IREDELL COUNTY HEALTH DEPARTMENT

SEPTIC IMPROVEMENT PERMIT / AUTHORIZATION TO CONSTRUCT / OPERATION PERMIT / EXISTING SYSTEM

Design proposal for a PPBPS Septic System with low pressure distribution for a 4 bedroom single family residence in RIVERSTONE AT ANNISTON LOT 8 Mooresville, Iredell County, North Carolina.

August 20, 2018
Job Number: 17076
Design By: BEN ALDRIDGE, REHS

AS BUILT SKETCH

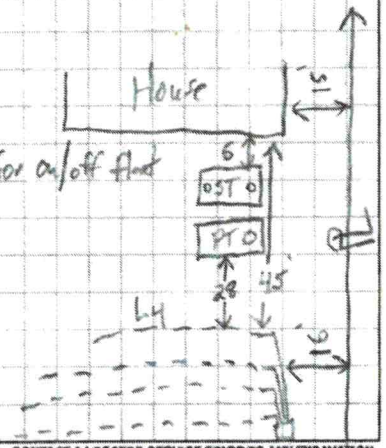
6/25/2020: OK to adjust line lengths to match site topo per LSS (site visit w/ Dennis Gallaher)

Left from house to tanks, parallel to house

Top line 78ft.

5/32 orifice drilled

62 × 3.6 = 223.2

7" drawdown for on/off float - Alarm OK

SITE DEVELOPMENT PLAN

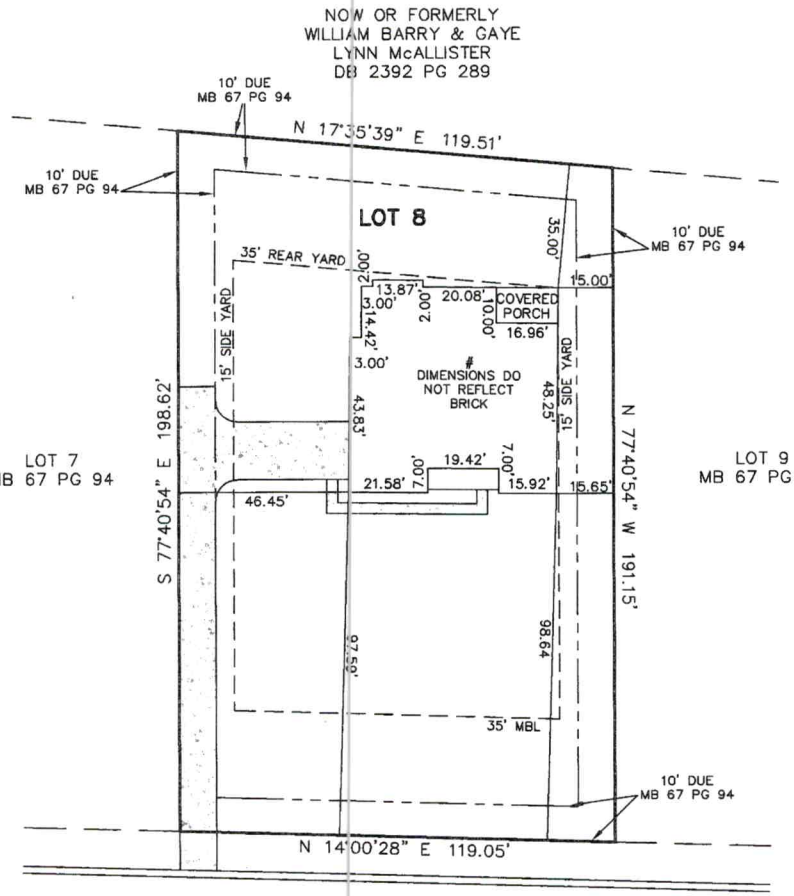
Comments / Conditions: 2/21/19: House being built is a side-loading garage variety. Though house is 2' wider than IP drawing house box, a 3' recess adjacent the owner's suite ensures no issues w/ repair area encroachment. No grading or cutting for 3' wide walkway in front yard to avoid disturbing repair area lines. See site development plan "Columbia" [dated 2/19/19] for location
